### Exhaust Manifold Bolt Usage

Bulletin No.: 47-66-03

Date: September, 1994

Figure 1

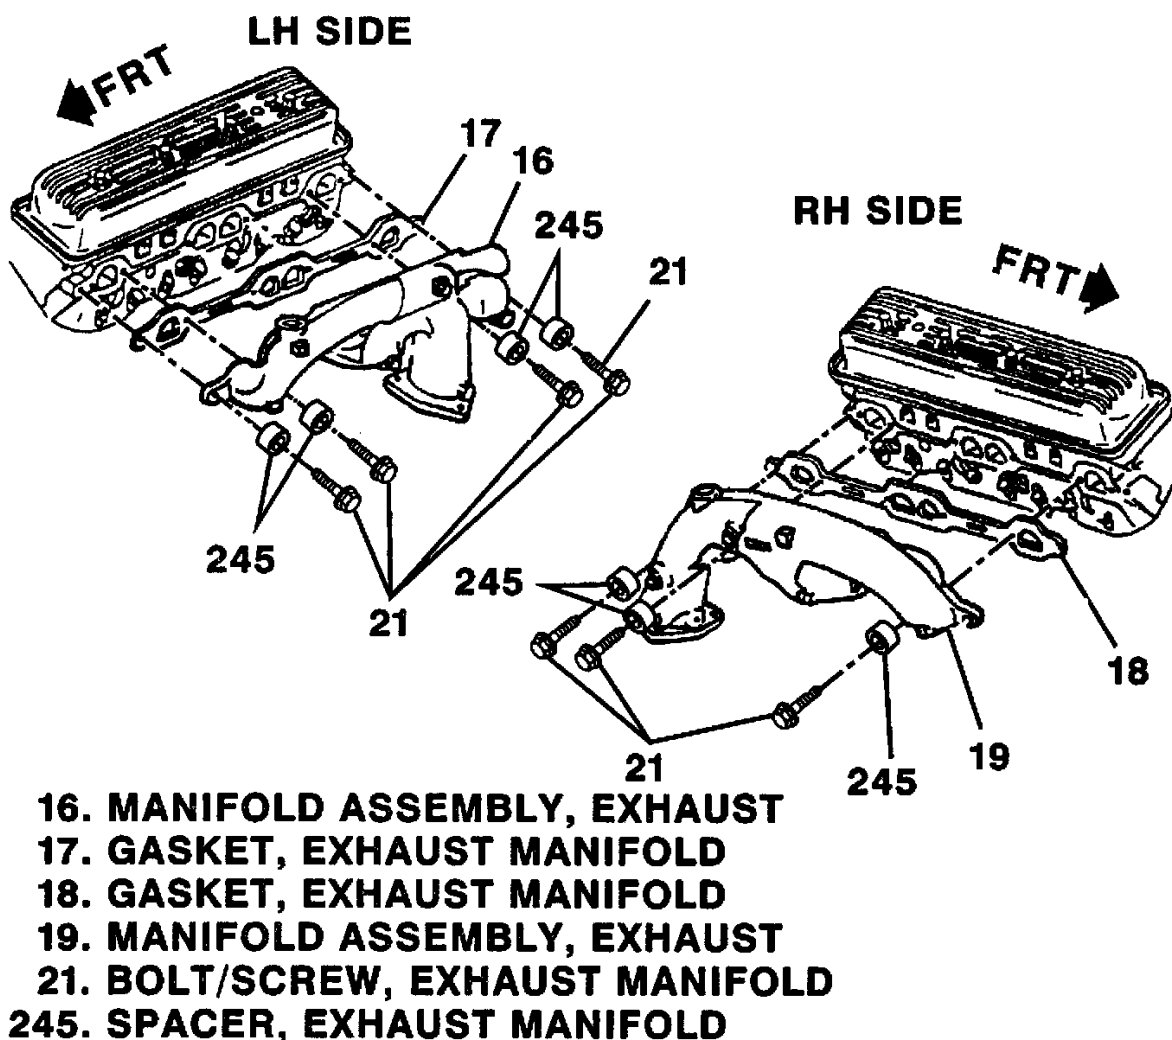
Vehicles built before the VIN breakpoints may have exhaust manifold bolts that bottomed out during assembly.

During any exhaust manifold service to the vehicles listed, install bolt 15538420 at locations 21, as indicated in the figure. At all other locations, install the standard replacement bolts. Apply a 1/8 inch bead of GM adhesive 12345493 to the bolt threads before reassembly.
